DEVELOPMENT APPLICATION ASSESSMENT REPORT

Application Number:	DA2022/0451
----------------------------	-------------

Responsible Officer:	Julie Edwards
Land to be developed (Address):	Lot 7 DP 217761, 7 Sherry Street MONA VALE NSW 2103
Proposed Development:	Demolition works and construction of a dwelling house and secondary dwelling
Zoning:	R2 Low Density Residential
Development Permissible:	Yes
Existing Use Rights:	No
Consent Authority:	Northern Beaches Council
Land and Environment Court Action:	No
Owner:	Rebecca Eleanor Gillespie Alexander James Gillespie
Applicant:	Blue Sky Building Designs Pty Ltd

Image 1: Non-compliance with rear building line and north side boundary setback

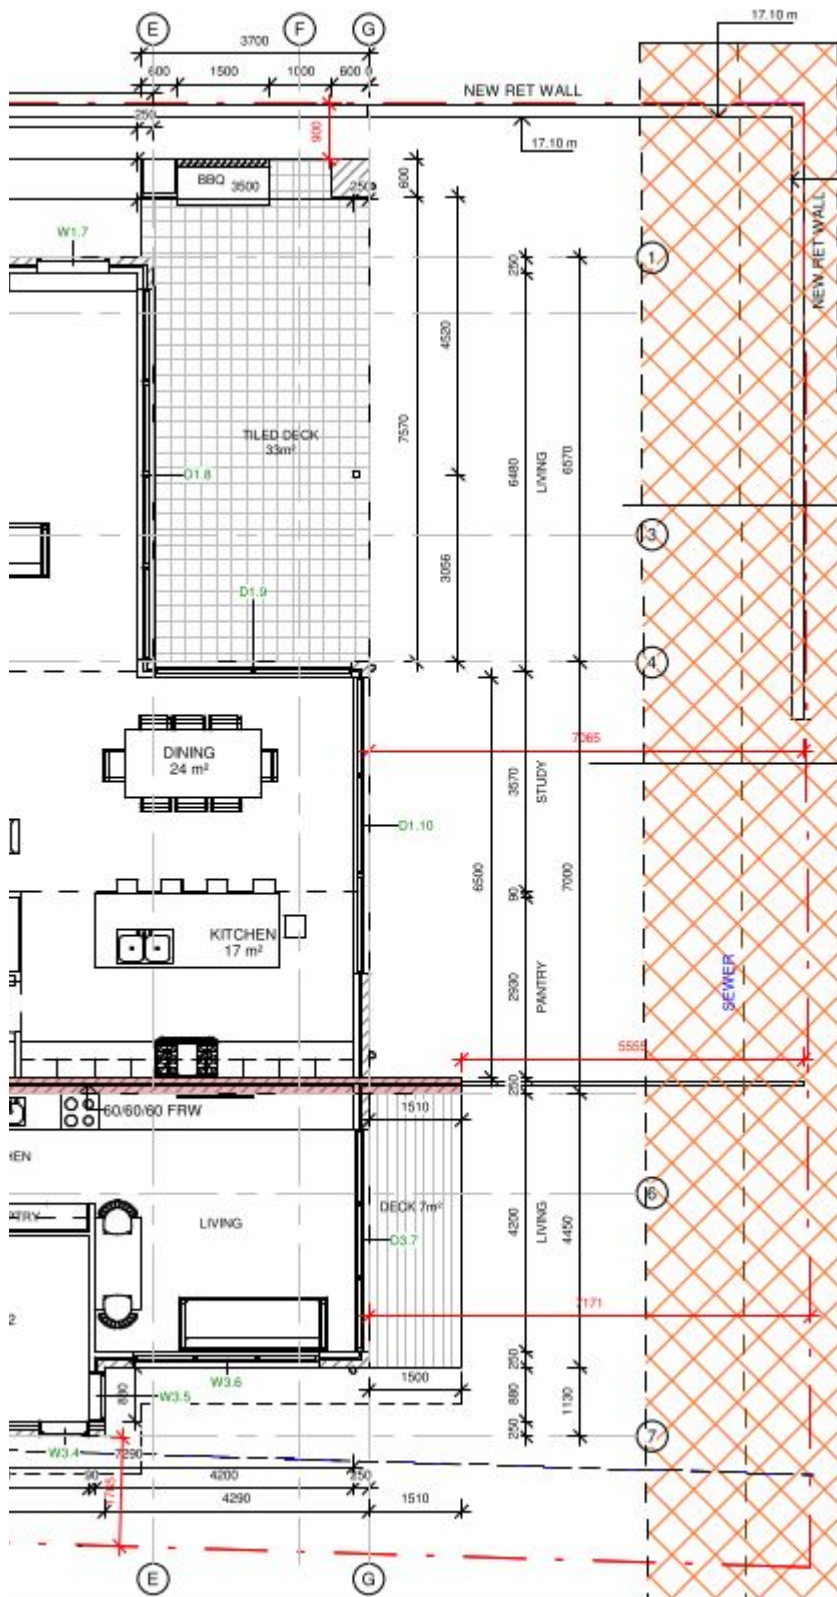
Clause D9.7 of the Pittwater 21 DCP requires development be setback at least 2.5m from the northern side boundary and 1.0m from the southern side boundary. The development proposes the following:

North side setback - 0.9m (Proposed tiled deck area).

South side setback - 1.75m (Proposed Secondary dwelling).

The rear deck of the secondary dwelling is set back 5.5m from the rear boundary. The main dwelling is setback 7.065m from the rear boundary. P21DCP requires structures to have a minimum rear setback of 6.5m.

The overall design of the dwelling is sited with varying setbacks, which ensure appropriate articulation and modulation along both side elevations. Despite non-compliance in small areas, the proposal is considered to be an appropriate response to the development of the site. Adequate pedestrian access to the site is maintained.
